HISTORIC AND DESIGN REVIEW COMMISSION

HDRC CASE NO: 2016-506
ADDRESS: 518 S ALAMO ST
LEGAL DESCRIPTION: NCB 13814 BLK 3 LOT SW IRR 416.30FT OF 12
ZONING: D,H,RIO-3
CITY COUNCIL DIST.: 1
DISTRICT: Hemisfair Historic District
APPLICANT: Isaac Ojeda/Dado Group
OWNER: Hemisfair Park Redevelopment Corporation
TYPE OF WORK: Additions, exterior modifications and signage
REQUEST:

**Historic and Design Review Commission
Design Review Committee
Report & Recommendation**

DATE: DECEMBER 14, 2016 HDRC Case# 2016-506

EXTERIOR
ELEVATIONS

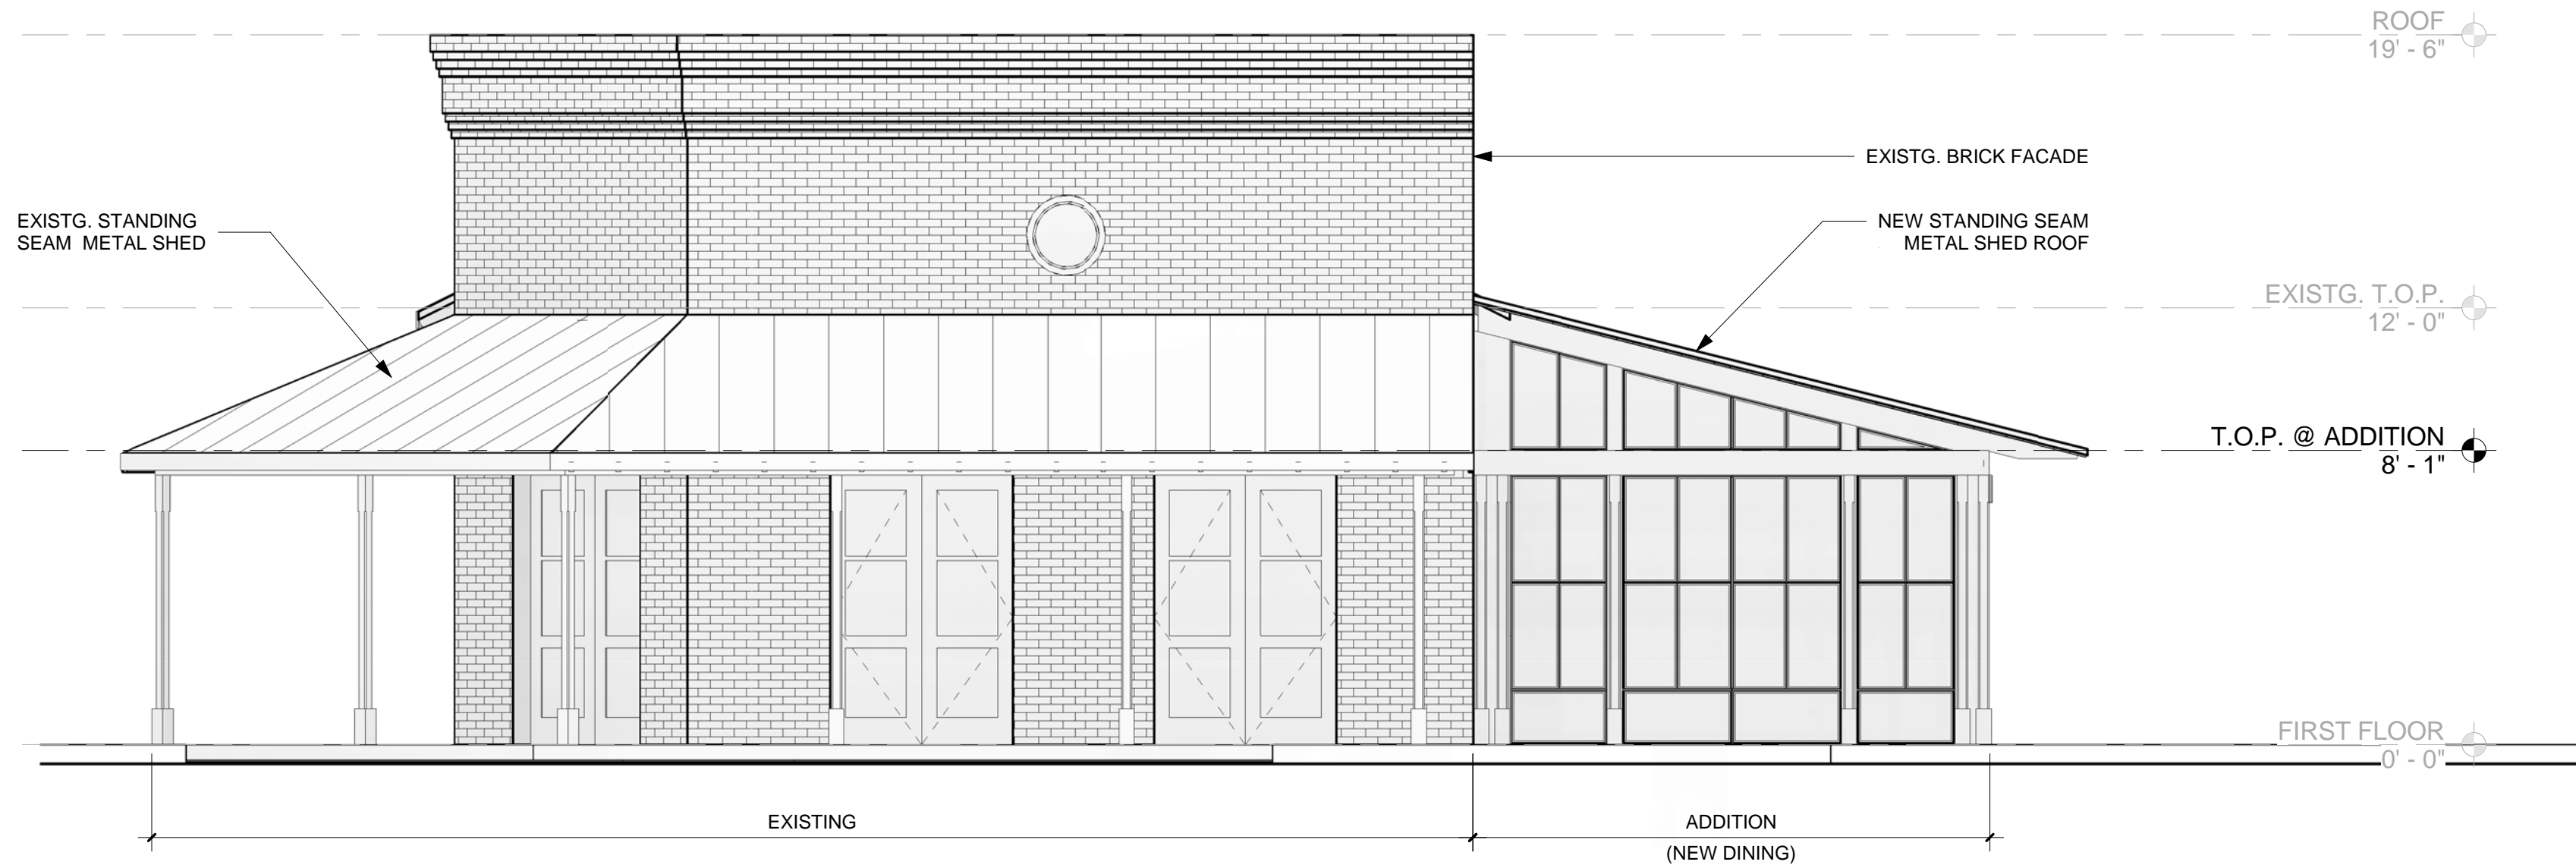
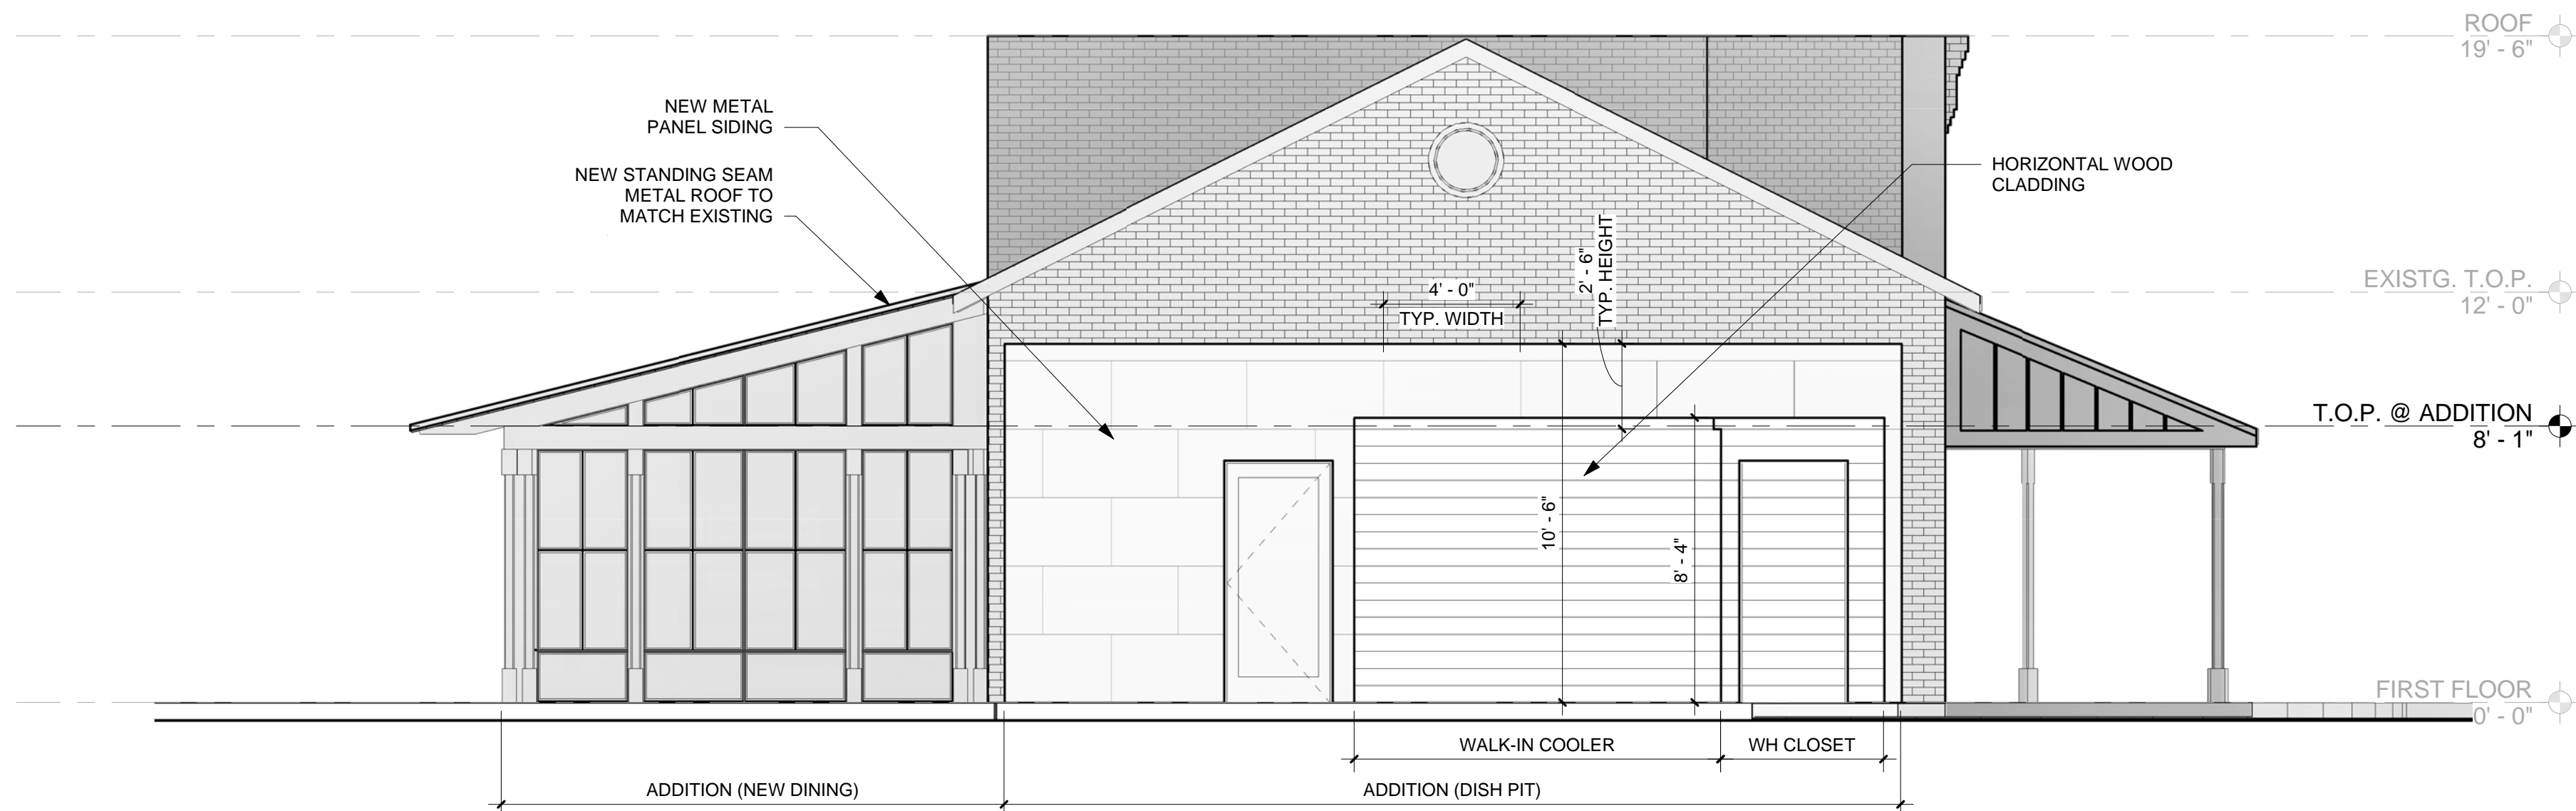
- d. EXTERIOR MODIFICATIONS – According to the Guidelines for Exterior Maintenance and Alterations 6.A., existing window and door openings should be preserved. In this instance, the applicant has proposed to reopen to door openings previously closed by masonry. Staff finds this proposal appropriate and consistent with the Guidelines.

- e. SIDE ADDITION – The applicant has proposed to construct a side addition to feature steel panels, a standing seam metal roof and glazing. While these materials do not directly relate to the primary historic structure, they are light in massing and allow for a transparent visualization of the primary historic structure. Additionally, staff finds that the proposed roof form allows for a minimal transition from the primary structure to the side addition.

- f. REAR ADDITION – At the rear of the primary historic structure, the applicant has proposed to construct an addition that is to house an office, restroom and storage area. The size of this addition has increased since the time of conceptual approval. Additionally, at conceptual approval, a walk in cooler was proposed to be located within the proposed addition. At this time, the applicant has proposed to locate the cooler to the rear of the addition.

- g. REAR ADDITION – The applicant has proposed to setback the proposed addition from the wall of the primary historic structure. This is consistent with the Guidelines for Additions. Regarding materials, the applicant has proposed to clad the addition with metal panel siding. The Guidelines for Additions 3.A.i., notes that complementary materials should be used in construction. While the proposed materials are inconsistent with the Guidelines, staff finds that in this instance, the proposed metal panels are appropriate.

- i. That the applicant clad the proposed walk in cooler with materials that are common to the property.
- ii. That the applicant screen all mechanical equipment from view at the public right of way, including that of the walk in cooler.
- iii. That the applicant install vegetation to screen the walk in cooler that is evergreen to provide natural screening year round.
- iv. ARCHAEOLOGY- The development project shall comply with all federal, state, and local laws, rules, and regulations regarding archaeology.

1. Front Exterior Sign
4' x 5'
est. sqft = 20'

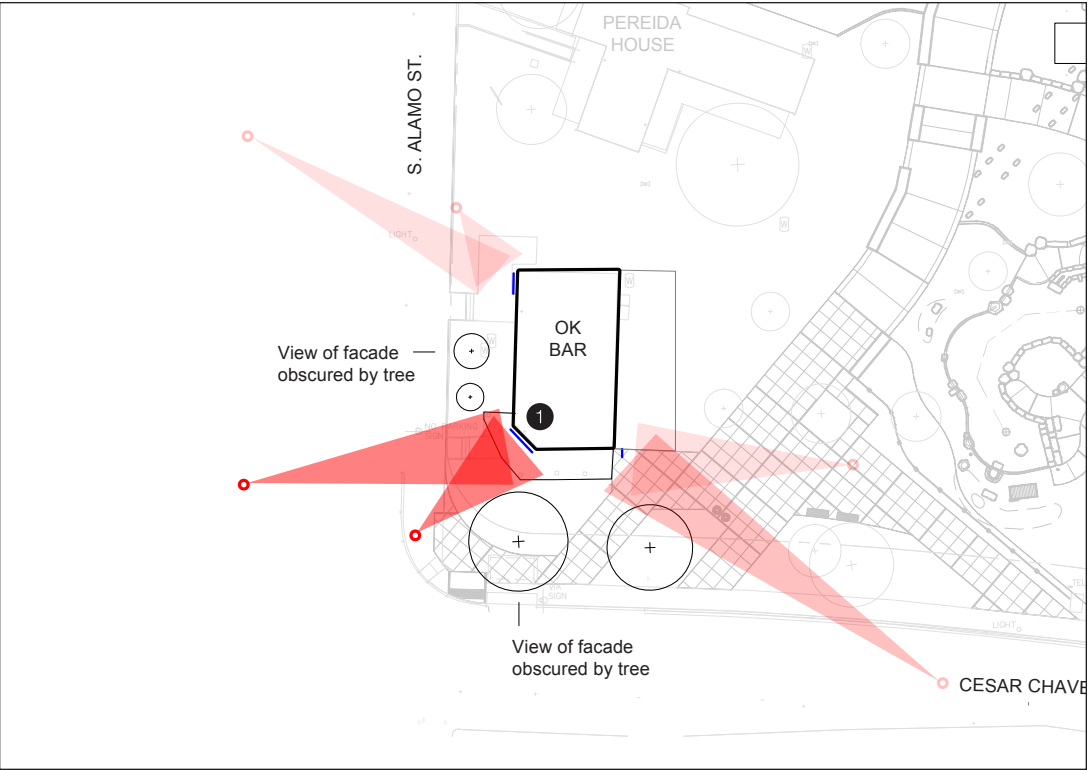
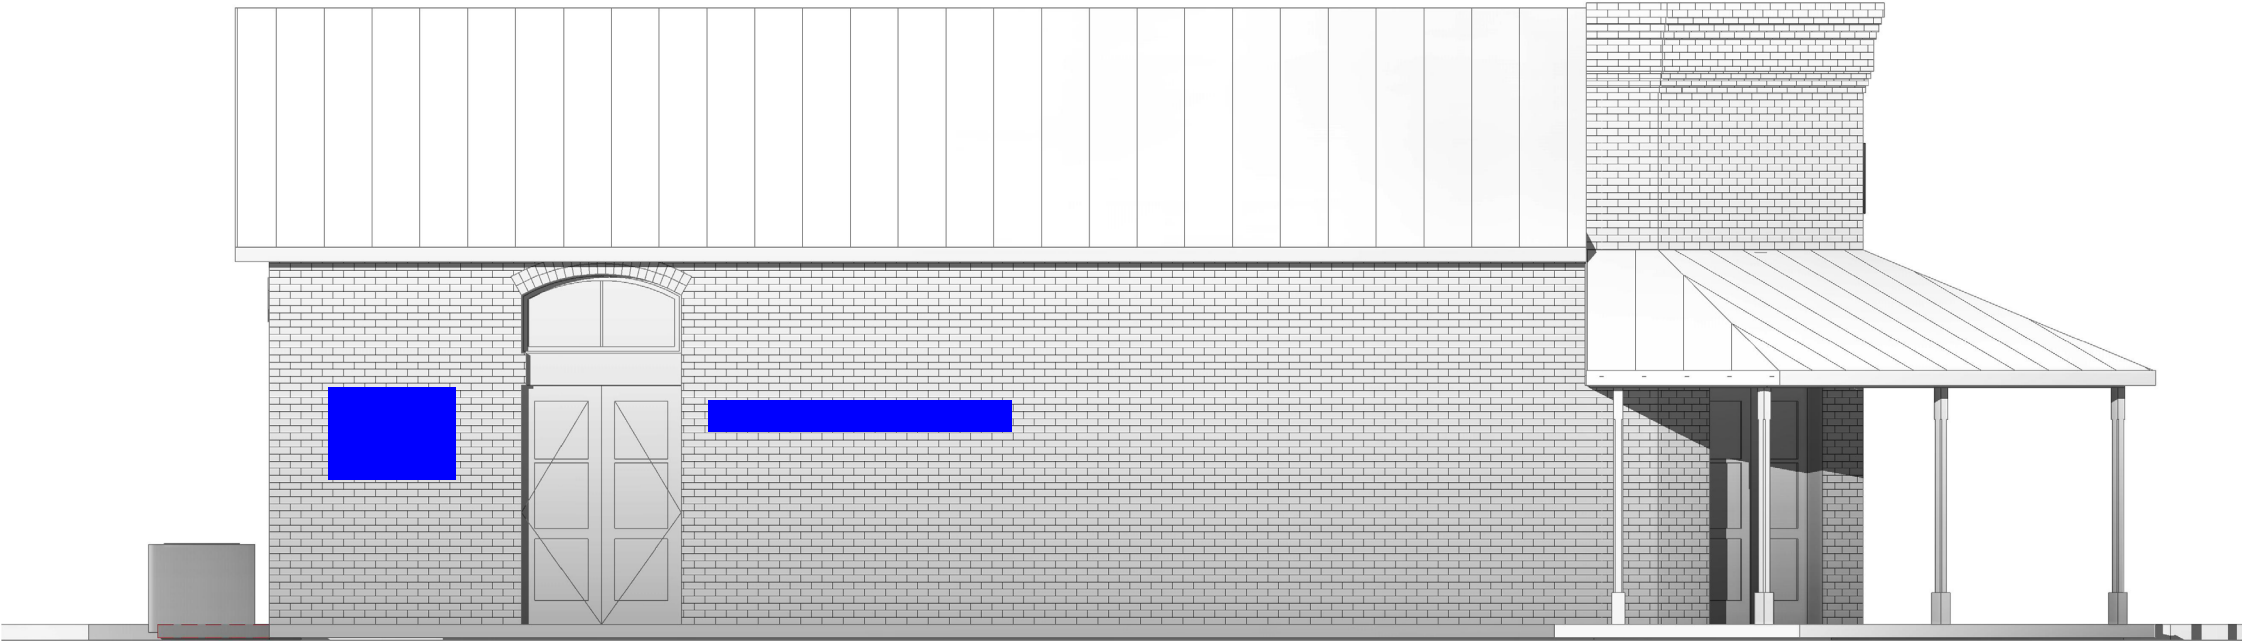
- i. SIGNAGE – The applicant has proposed to install signage at various locations on the structure. The applicant has proposed to install a parapet wall sign to feature channel letters, indirect illumination and twenty (20) square feet.,

a two painted signs featuring approximately twenty-three (23) square feet and a projecting blade sign featuring neon lighting and four (4) square feet. Staff finds the location and installation of each of these signage appropriate.

REFLECTIVE. MG: SIGNAGE IS APPROPRIATE; PAINTED SIGNAGE IS APPROPRIATE.
